July 26, 1968

We have your letter of July 22, 1968, approving in principle our proposed sanitary landfill operation for this plant.

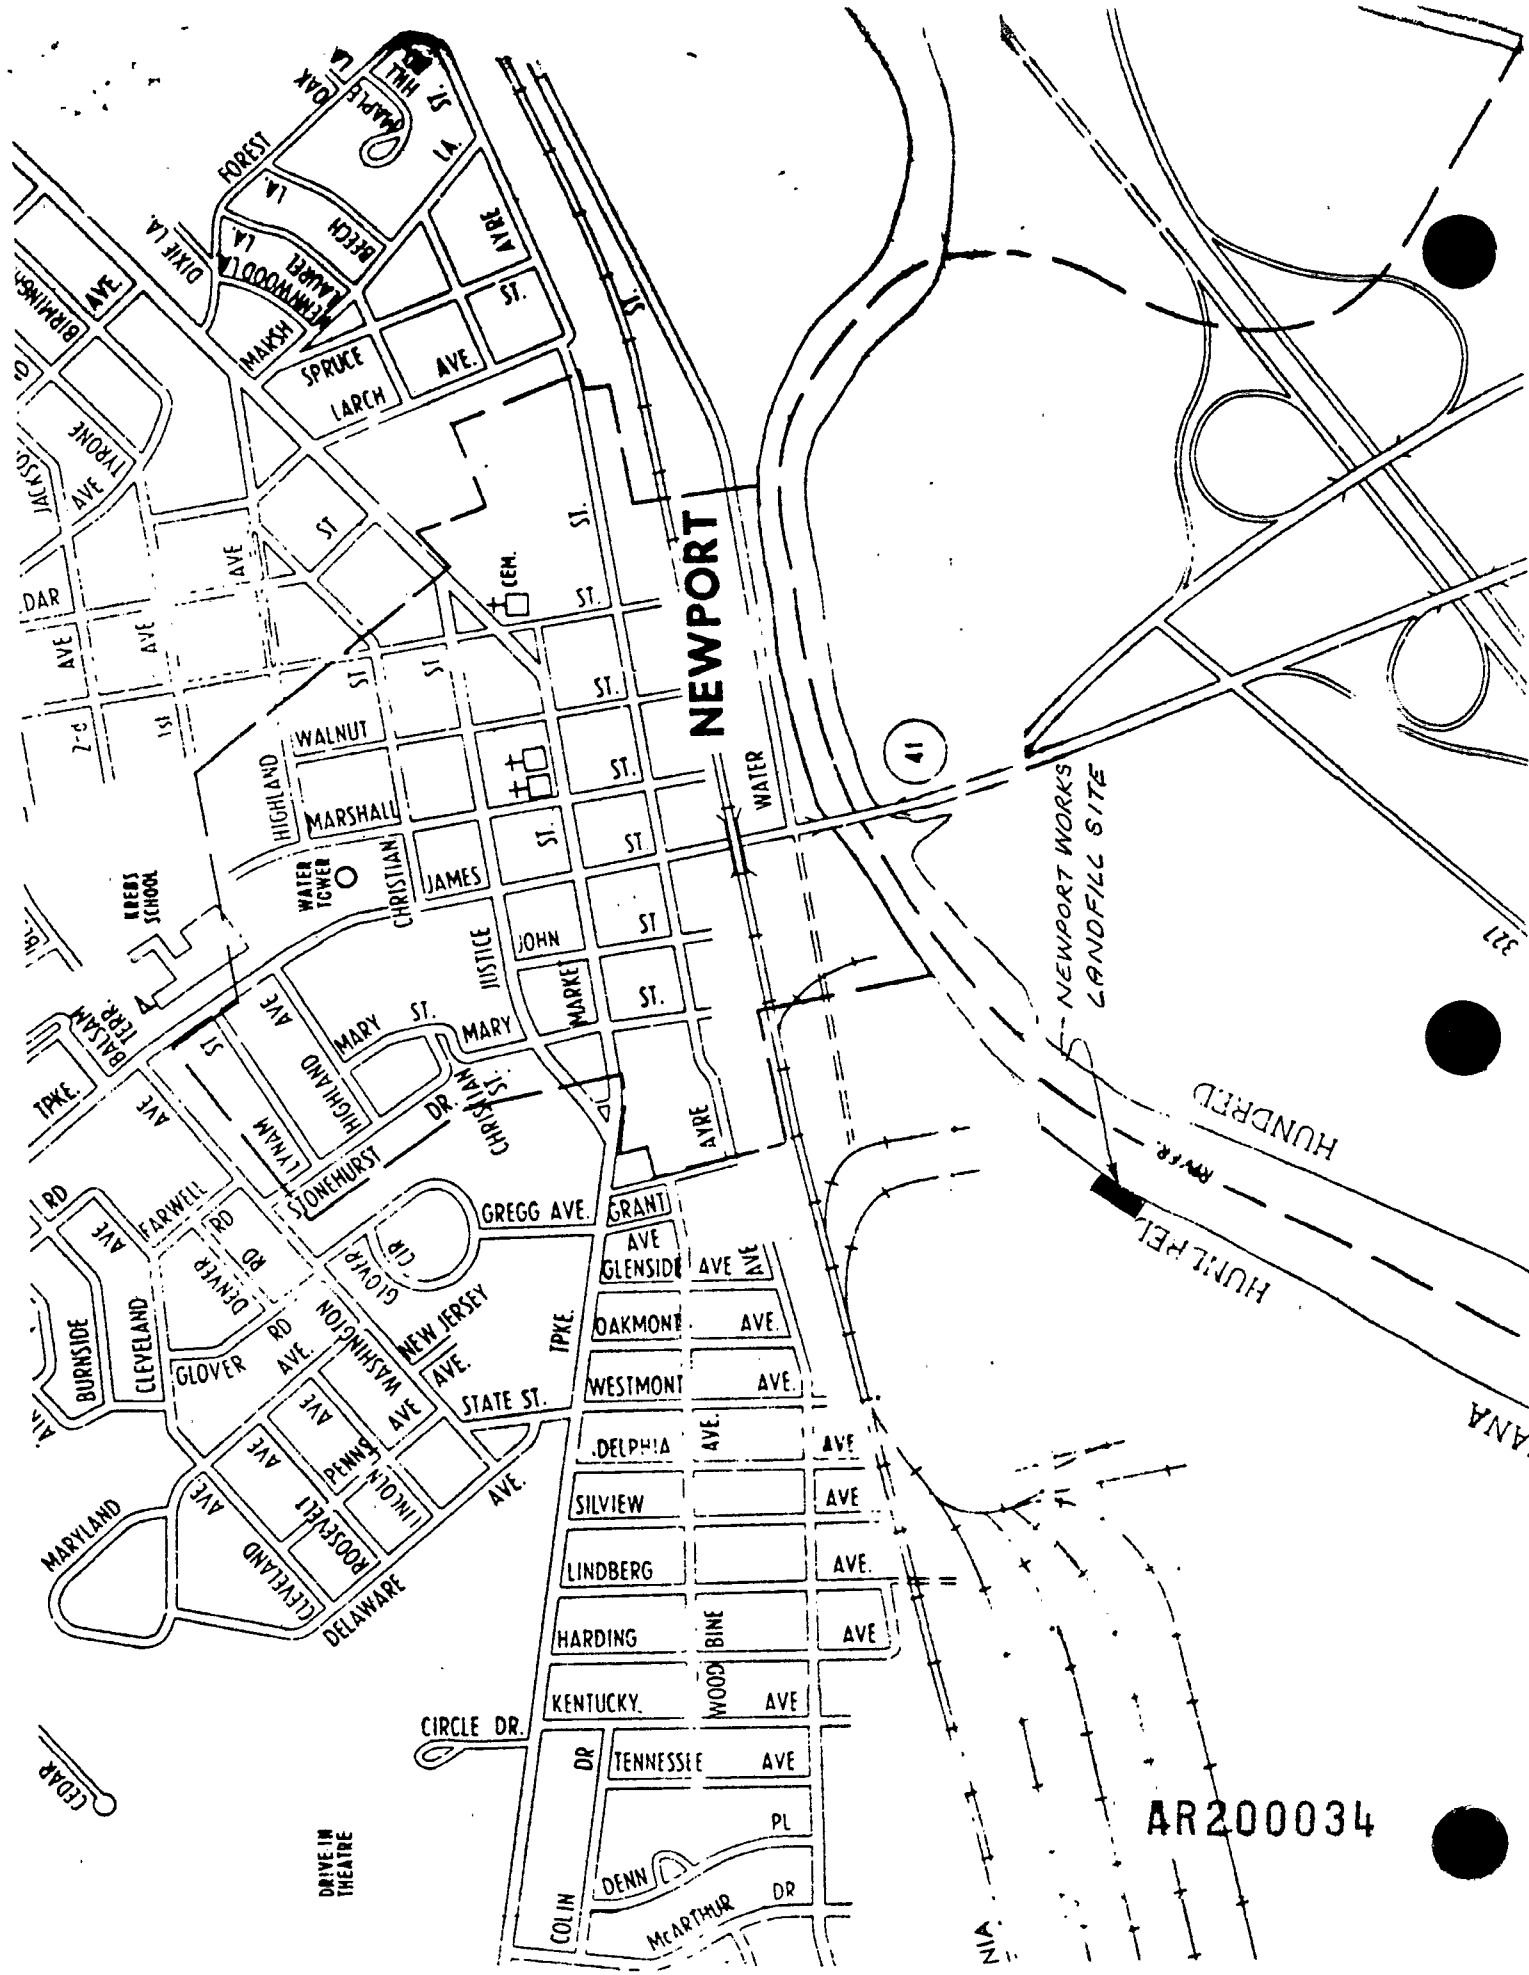
You requested additional information on the following to satisfy your requirements:

1. Location on the landfill site where the different materials will be segregated. The attached map shows the landfill site with respect to the plant and adjacent area. A second chart shows an enlargement of the landfill site only, and on this we have indicated where the various materials will be placed.
2. The width of the working face will be 40 to 50 ft. The height of this face will be reduced from 15 ft. to 7-8 ft. under our new plan, recommended by Mr. Wilburn, to fill from below and make a new lift.
3. In accordance with your recommendation, we agree to cover the more readily oxidizable materials to a depth of 4 inches on the top and face.
